Submission to the Planning Inquiry
PROOF OF EVIDENCE – DELIVERY & CONSTRUCTION RISKS
[MATTERS 1, 2, 4, 5, 9, 12 & 14]
Prepared by R. Harman CEng MCISBE

**Scheme: Application by Oxfordshire County Council : planning application number
R3.0138/21**

**Title: Dualling of the A4130 carriageway, construction of the Didcot Science Bridge, road
bridge over Appleford railways sidings and road bridge over the river Thames and
associated works between:**

CASE REF: APP/U3100/V/23/3326625.

Ref Drawing: R3-01238-21-DATOM-001

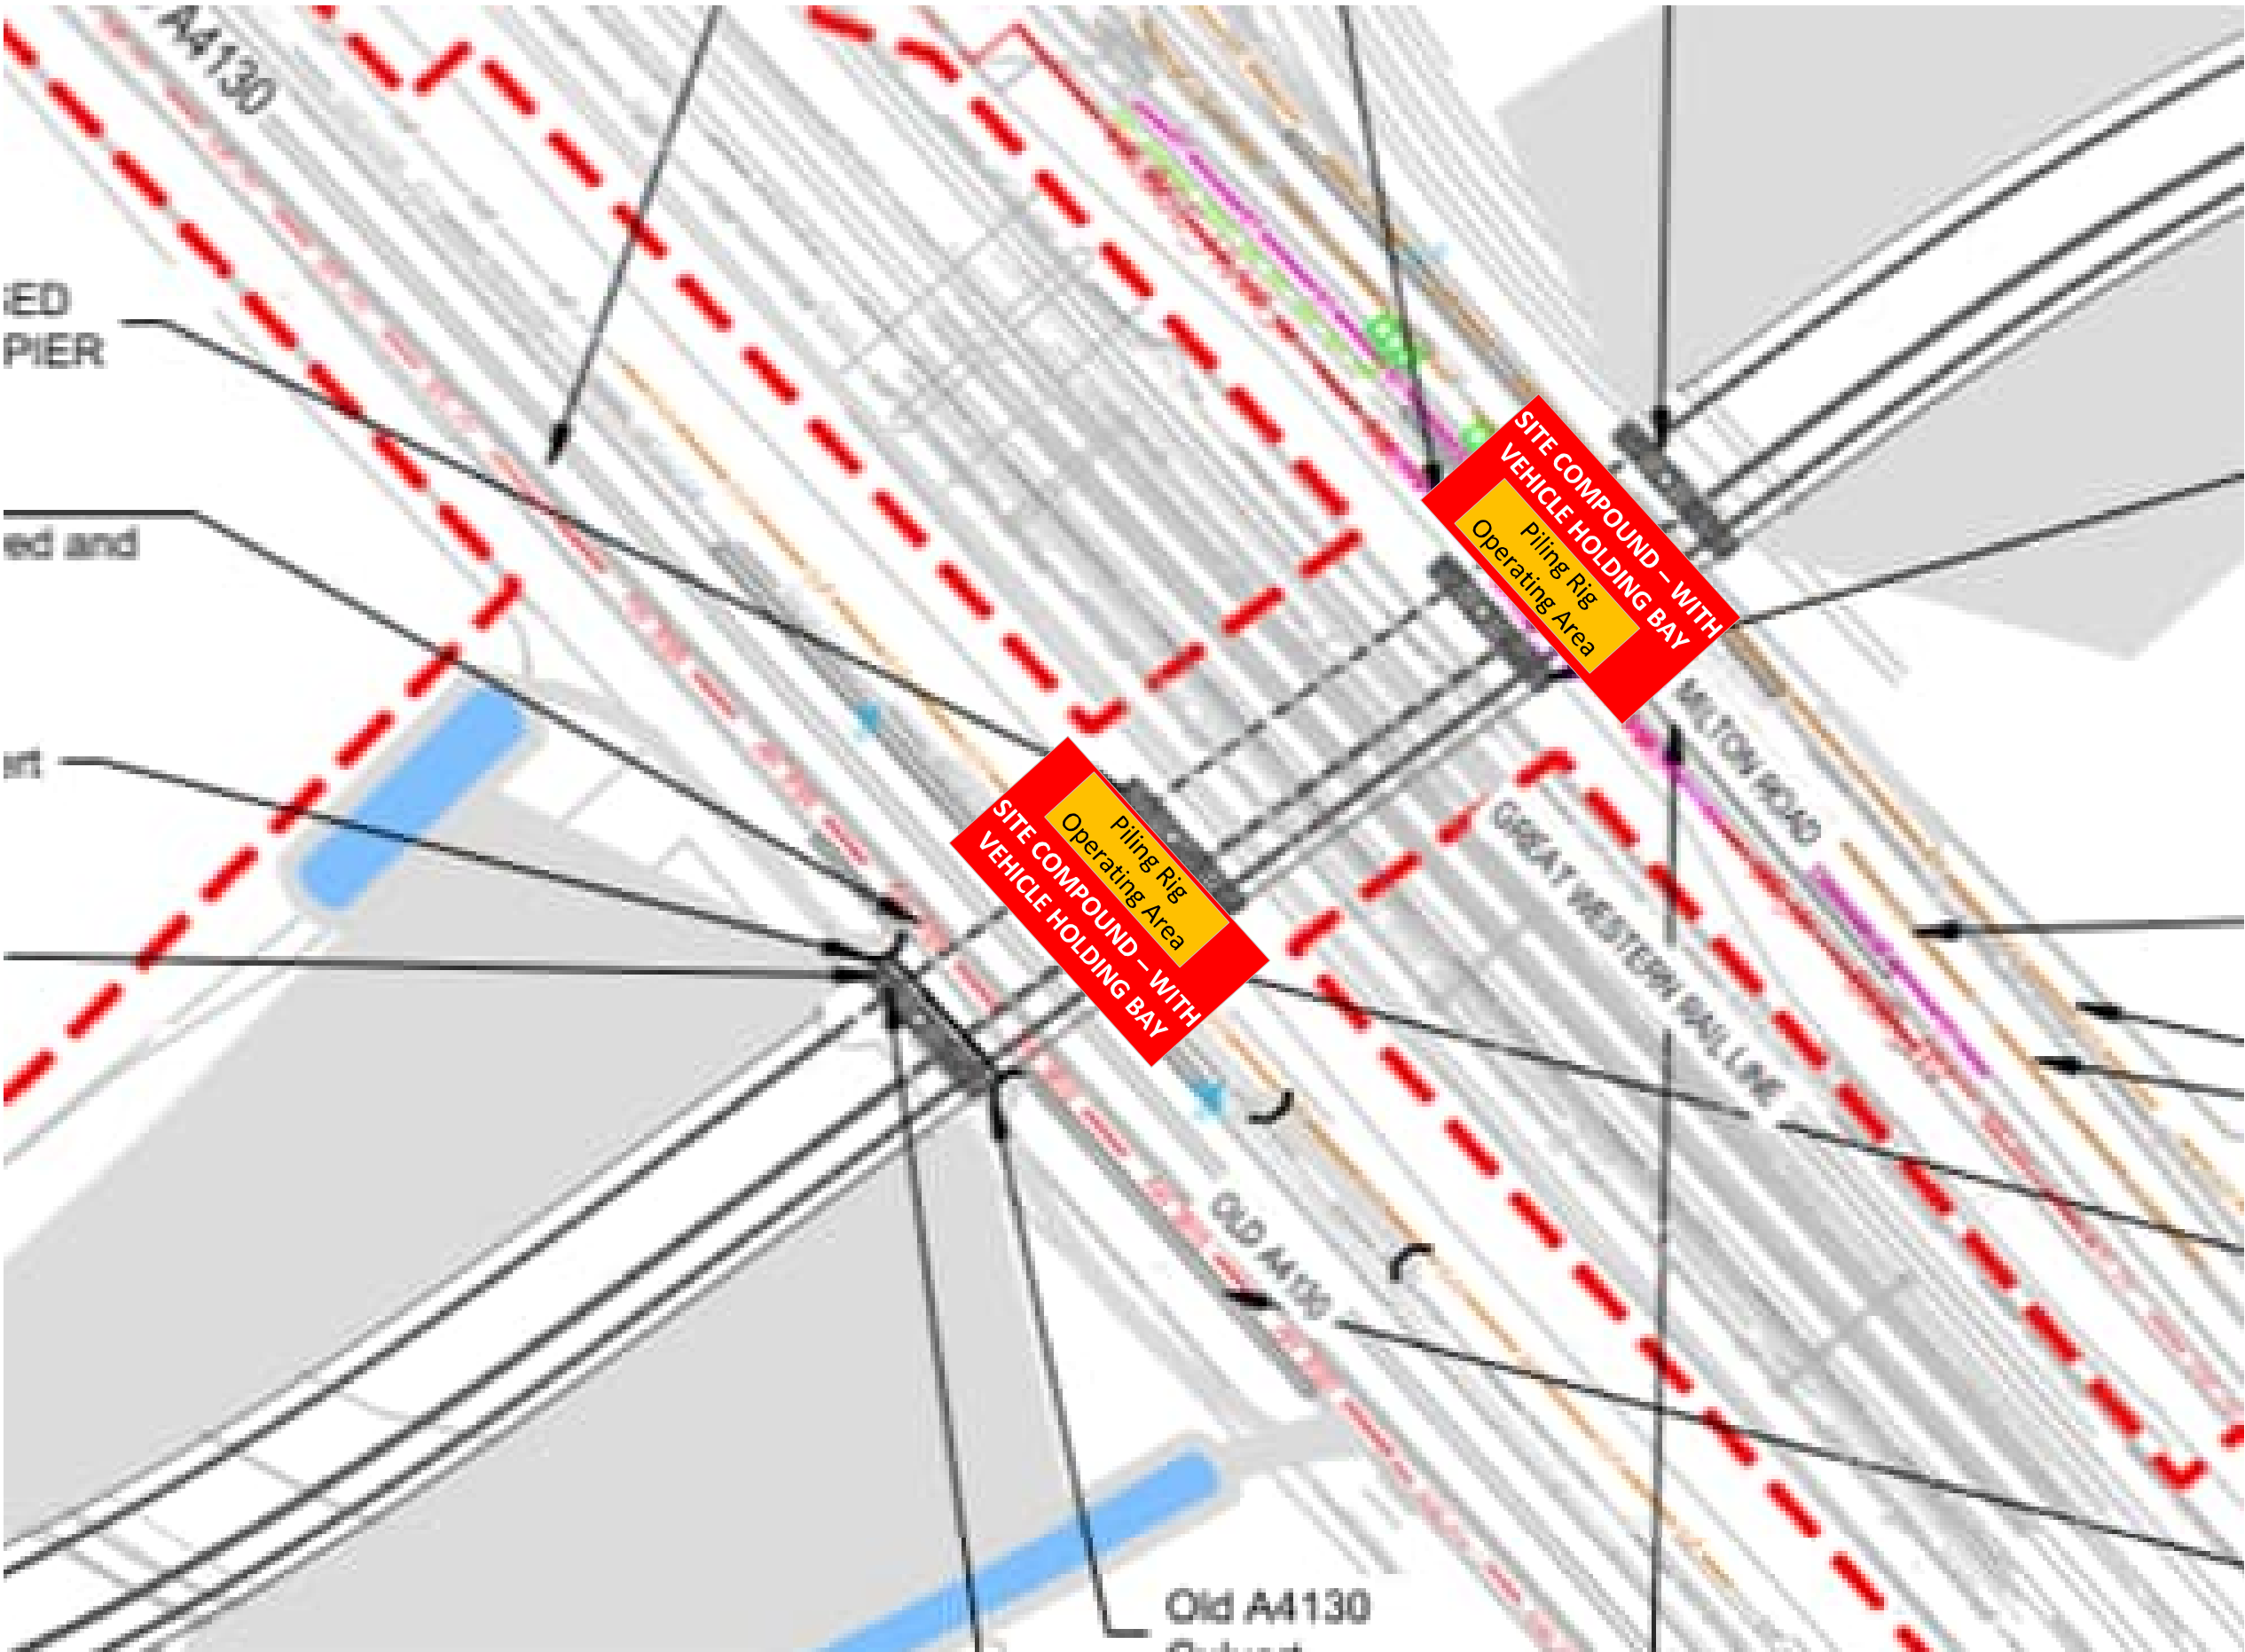
Whilst the A4130 Construction Plans show the phasing of how the dual carriageway is to be constructed, it does not consider the specific site compound with associated lane closure(s) for the construction of the Science Bridge Piles, Ground Beams and support Columns.

- A4130 Lane Closure – Ground Clearance and Interim Boundary realignment onto NR Property Compound [night shift].
- A4130 Lane Closure – Establish Localised NR Site Compound [day shift]. *[See Drawing R3-01238-21-DATOM-001]*
- A4130 Lane Closure – Piling of South Bridge Abutment [day shift].
- A4130 Lane Closure – GWRL South Piling – Bridge Pier [night shift#]
- A4130 Full Road Closures – Heavy Lifts – positioning of the Steel I Beams and the GRC Permanent Formwork. *[Probably over a GWML Easter Possession Holiday Period].*

- Milton Road Lane Closure – Ground Clearance and Interim Boundary realignment onto NR Property Compound [night shift].
- Milton Road Lane Closure – Establish Localised NR Site Compound [day shift].
[See Drawing R3-01238-21-DATOM-001.]
- Milton Road Lane Closures – Piling of North Bridge Abutment [day shift].
- Milton Road Lane Closures – GWRL North Piling – Bridge Pier [night shift#].
- Milton Road Full Road Closures – Heavy Lifts – positioning of the Milton Road Steel I Beams and the GRC Permanent Formwork.
- Milton Road Full Road Closures – Heavy Lifts – positioning of the GWML Steel I Beams and the GRC Permanent Formwork. *[Probably over a GWML Easter Possession Holiday Period].*
